LETTER OF SUBMITTAL
KFM Skyway Project # 04-012024

SUBMITTAL No: KFM-SUB-002144

Subject: USI - KFM NCR #28R1 (USI NCR #04-25 Rev.1) Response to CTL - 4439

Universal Structural, Inc NONCONFORMANCE REPORT

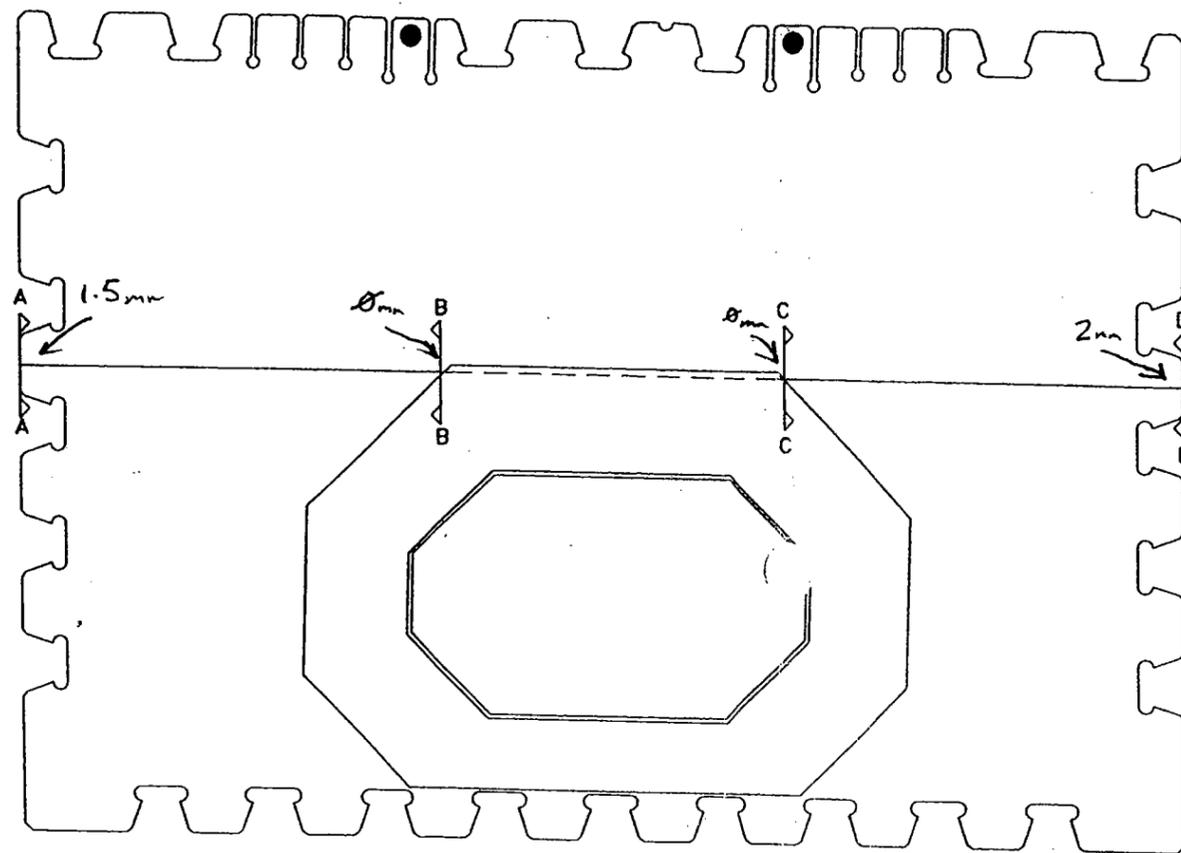
NONCONFORMANCE:
Wing plate diaphragm pa87 has excessive weld distortion in the butt weld. From the left end looking at the shop drawing, the end is 20 mm out of flat tapering to 13 mm at the left side of the doubler plate. From the right side of the doubler plate, the weld is 10 mm out of flat tapering to 8 mm at the other end.

Revision 1,
As requested, a sketch needs to be supplied to indication location of excessive distortion.

Caltrains requires witnessing the repair and will only allow one heat progression.
Record results after line heats are cooled.

RECOMMENDED DISPOSITION:
Areas distorted by welding shall be straightened by application of a limited amount of localized heat with minimal mechanical assistance. The temperature of heated areas shall not exceed 1100 degrees F. (600 degrees C.).
All application of heat to base metal shall be controlled by using Temp Sticks or Thermocouples to assure that heat does not exceed allowable. Weld joints are to be heated on both sides, parallel to the weld. This line heat will be located approximately 1 to 3 inches from the weld joint on the outside of the surface that is distorted.

Revision 1,
Please find the attached sketch for location and amounts of distortion

DIAPHRAGM "pa87"

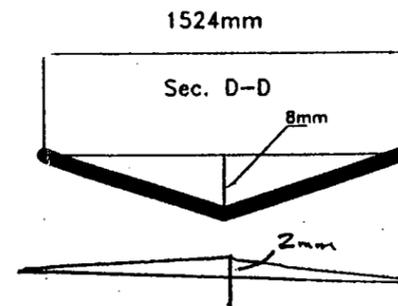
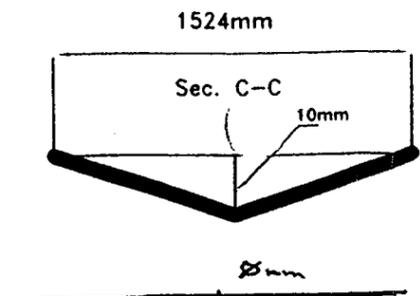
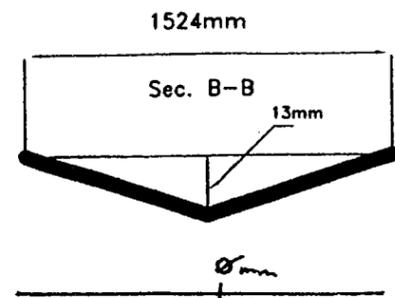
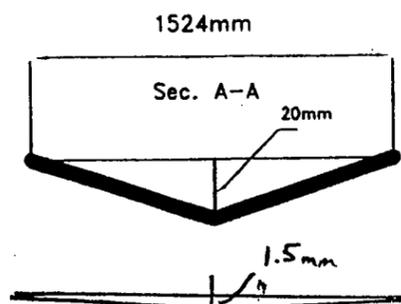
The State has reviewed KFM-SUB-002144R01: USI NCR 04-25 Rev.1 - Dimensions regarding the request to heat straighten weld distortion in the butt weld in wing plate diaphragm pa87. The State will allow USI to apply one progression of heat in accordance with USI's "Typical Butt Weld Distortion Repair Procedure" included with this submittal. Heat straightening should occur in the presence of a State QA inspector. After the first progression of heat is applied, the measurements of the affected dimensions should be communicated to the State QA inspector on the shop floor. At this time, the State may approve the second progression of heat in accordance with the "Typical Butt Weld Distortion Repair Procedure." Subsequently, non-destructive testing (NDT) shall be performed in accordance with AWS D1.5 Section 6.7.3.

The State also requests future submittals include additional information concerning the overall deviation from flatness. In addition to the deviation from flatness measured across the 1524 mm length at localized areas of distortion, the State requests the deviation from flatness measured across the total edge-to-edge distance perpendicular to the weld.

The Engineer has reviewed KFM-SUB-002144R02: USI KFM NCR #28R1 (USI NCR #04-25 Rev.1) Response to CTL. The Engineer takes no exception to the subject submittal and agrees the Contractor has sufficiently addressed this NCR. As a result, USI NCR 04-25 Rev.1 is resolved.
